Calibration Review

Keita KAWABE, LIGO Hanford Observatory
on behalf of the Calibration Review Committee

Example of Bad period

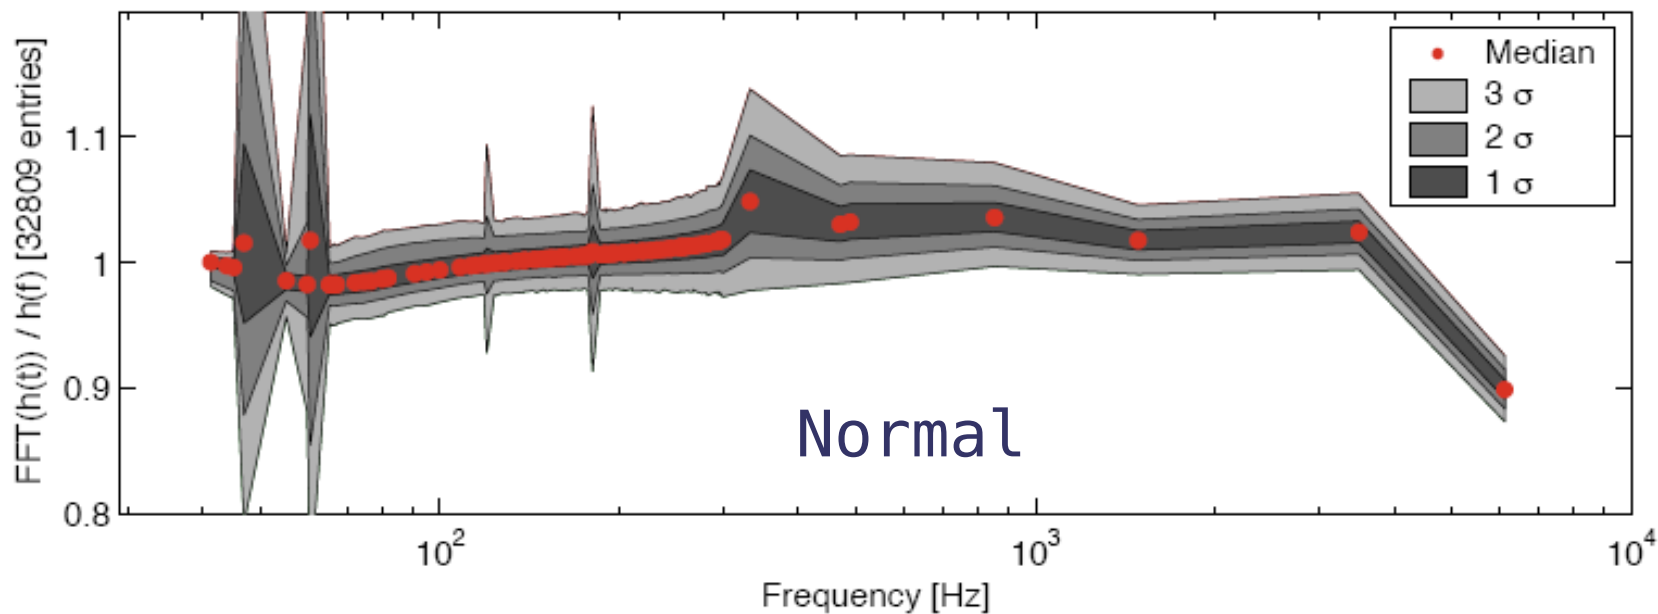
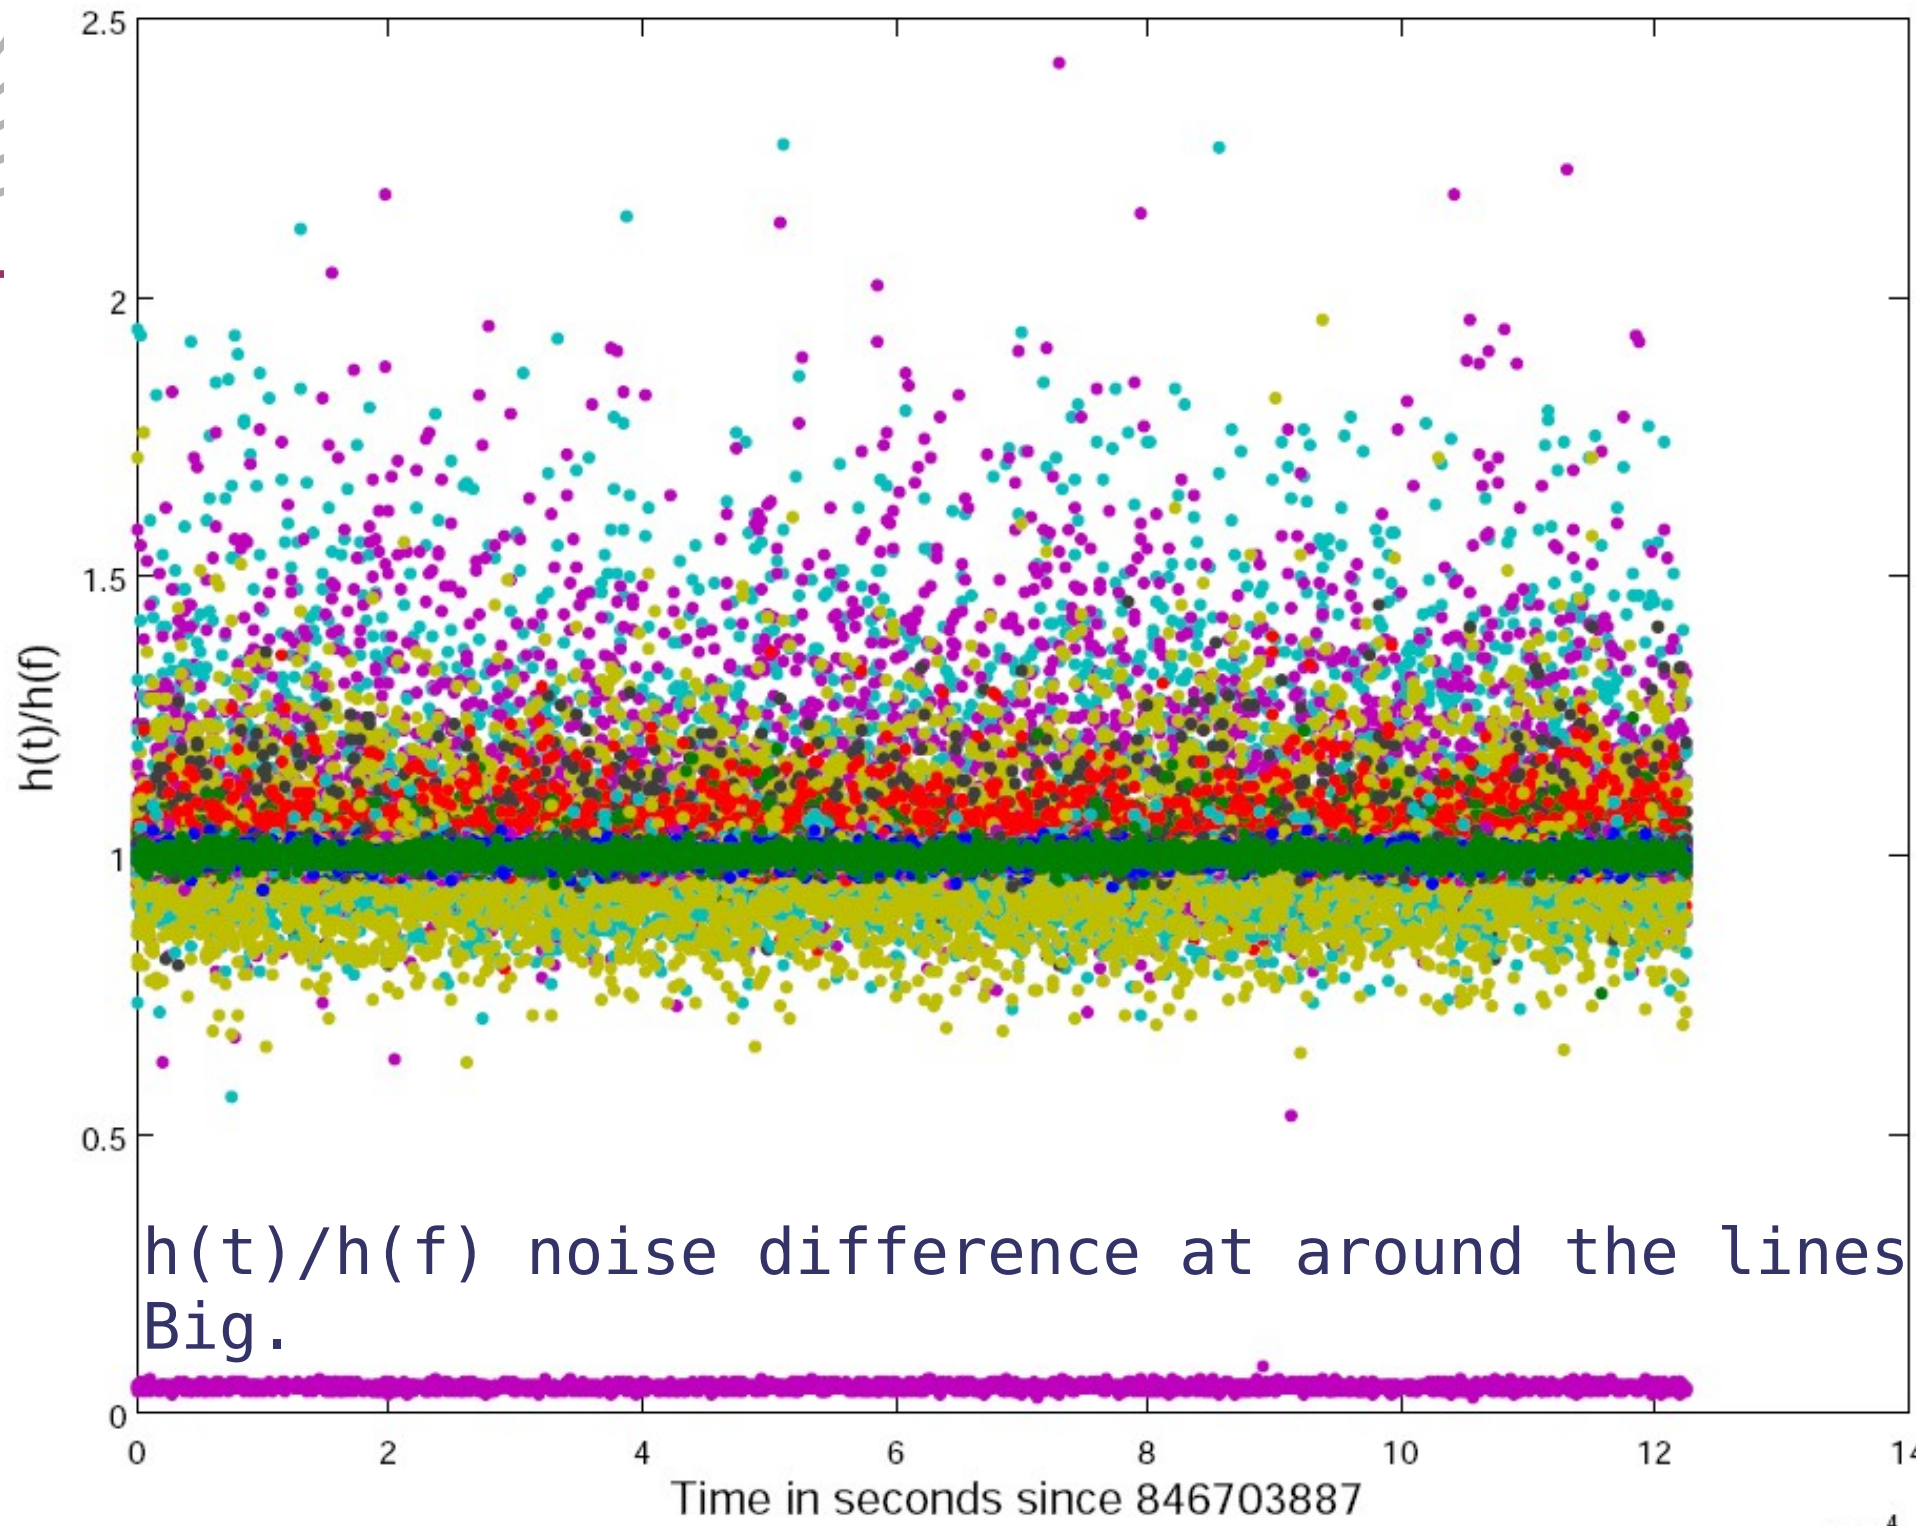
- Limited test and sanity check.
 - Code review.
 - Calibration factor study.
 - Injection study (burst) by Eiichi/Xavi
 - $h(t)$ - $h(f)$ comparison (SamW)
 - 10% of S5 3-coincidence.
 - 100 randomly chosen frequency bins
- Two problems found despite the limited scope of the noise comparison.
 - Bad $h(t)$ production period, H1 and L1.
 - $h(t)/h(f)$ noise difference at around lines.
